Public Hearing: Asa's View Subdivision

Preliminary Plat, Variance, SEPA Mitigated Determination of Non-significance (MDNS), Critical Areas Permits, Legal Lot Determination, and Tree Cutting Permit: Type III Review

DRAFT Staff Report & Recommendations

(#2022-022-SUB/SEPA/CAR/LLD/VAR/TRE) November 21, 2022

INDEX NUMBER 10 OF 11

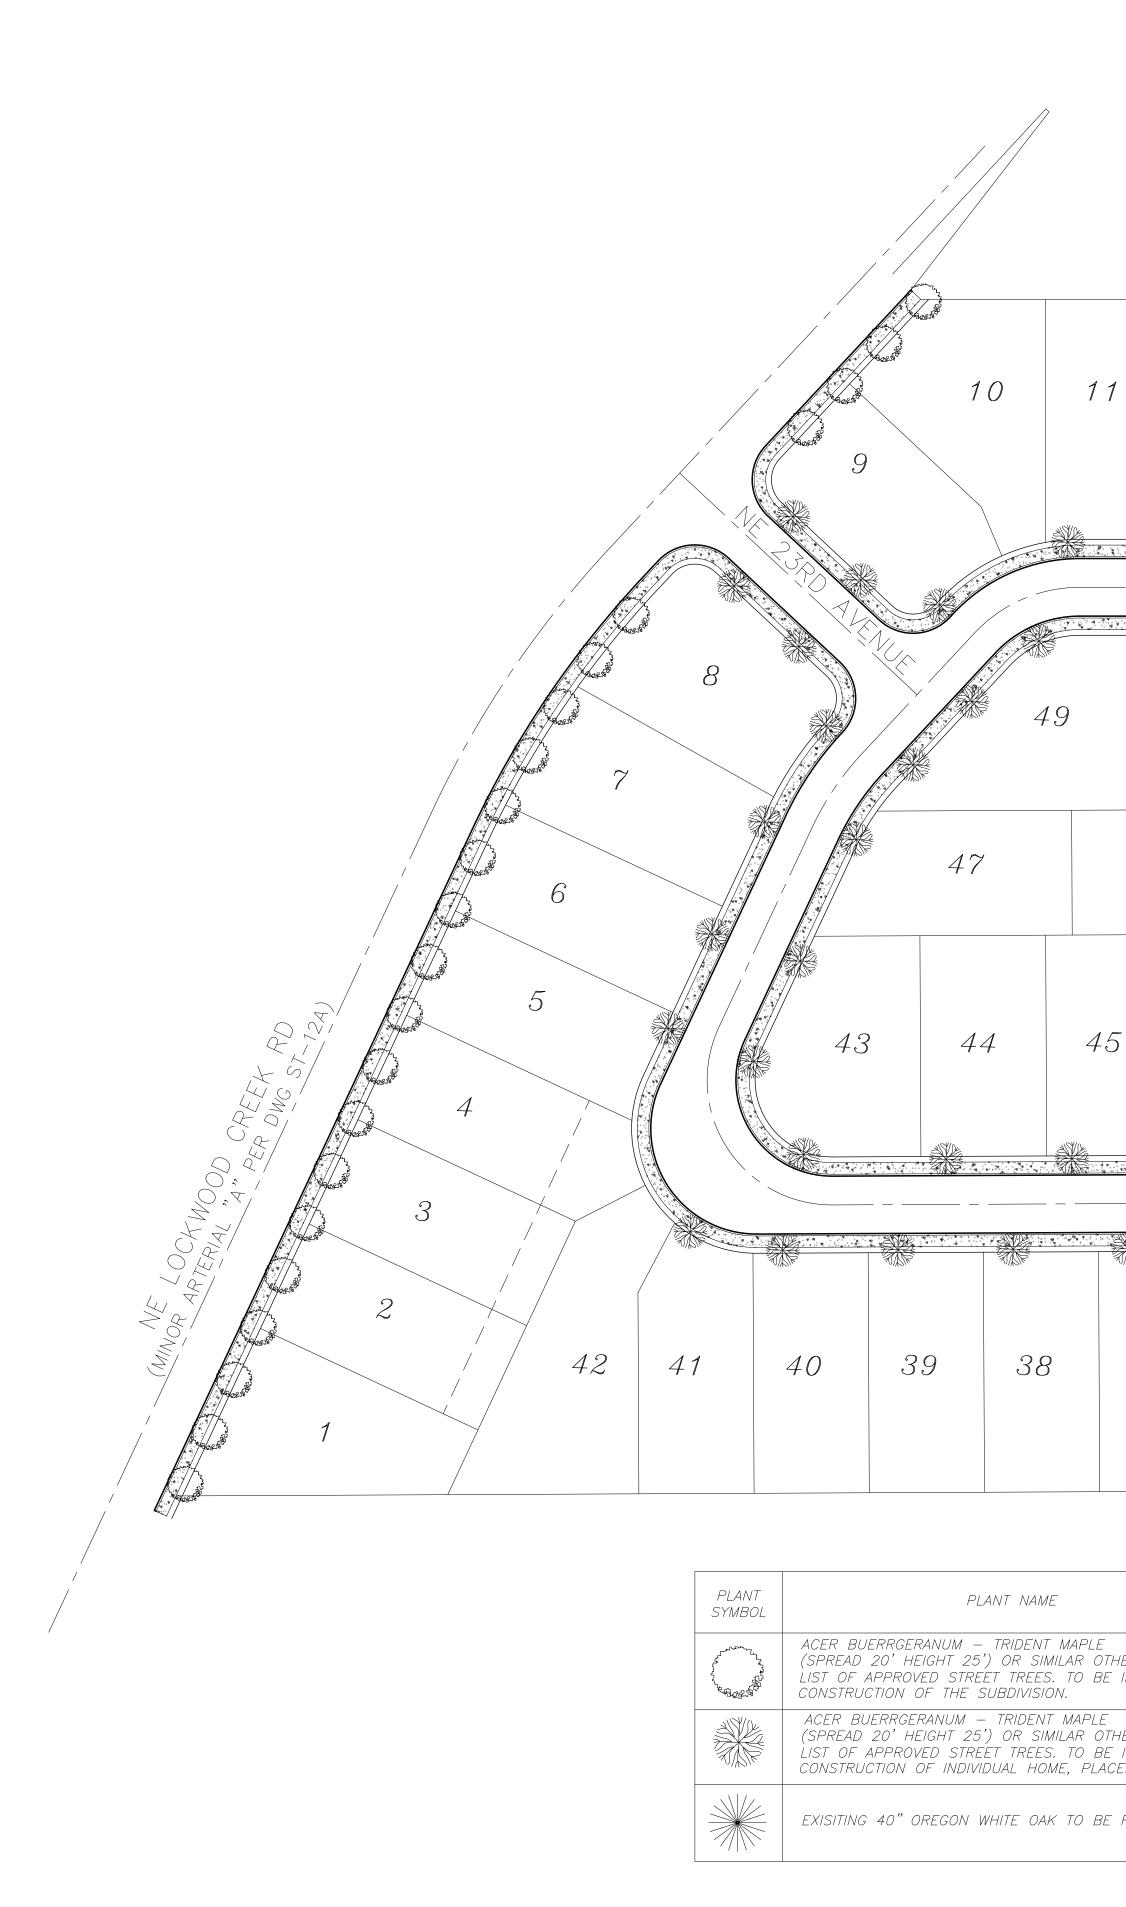
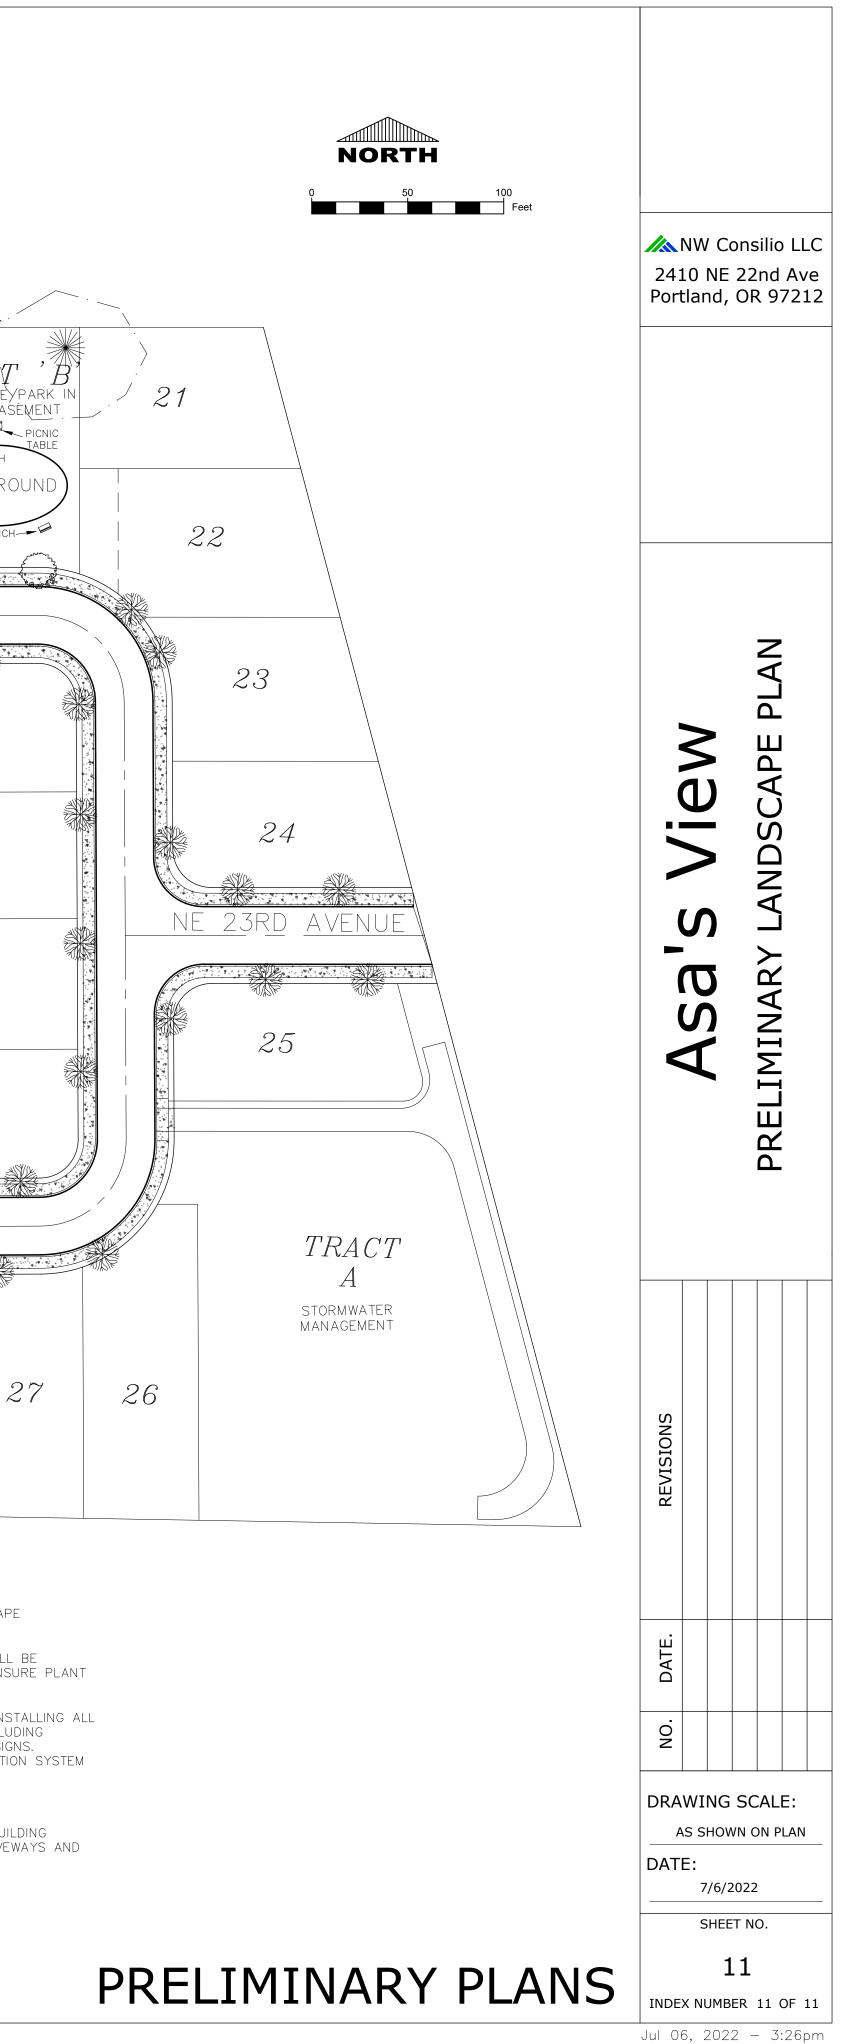
- The undeveloped play space includes the Oregon white oak; however, no vegetation and irrigation plans are shown. A condition of approval will require that applicant's final park plan show vegetation in the undeveloped play space and an underground irrigation system for all vegetated areas, except within the dripline of the Oregon white oak as specified in the critical areas report.

- The applicant's park plans show a fence adjacent to lots 20, 21, and 22. However, this proposed fence crosses through the drip line of the White Oak tree, which is a designated critical area. The provided critical areas report states that it's recommended that no below the surface improvements of any kind occur within the tree's dripline, including fence posts, as conditioned in LCMC 18.300 in this staff report.

As **a condition of approval**, the applicant's final park plan shall show vegetation in the undeveloped play space and an underground irrigation system for all vegetated areas except within the dripline of the Oregon white oak as specified in the critical areas report.

As **a condition of approval**, the applicant's final park plan shall show a low fence or vegetative barrier that is not sight obscuring where the park abuts residential lots.
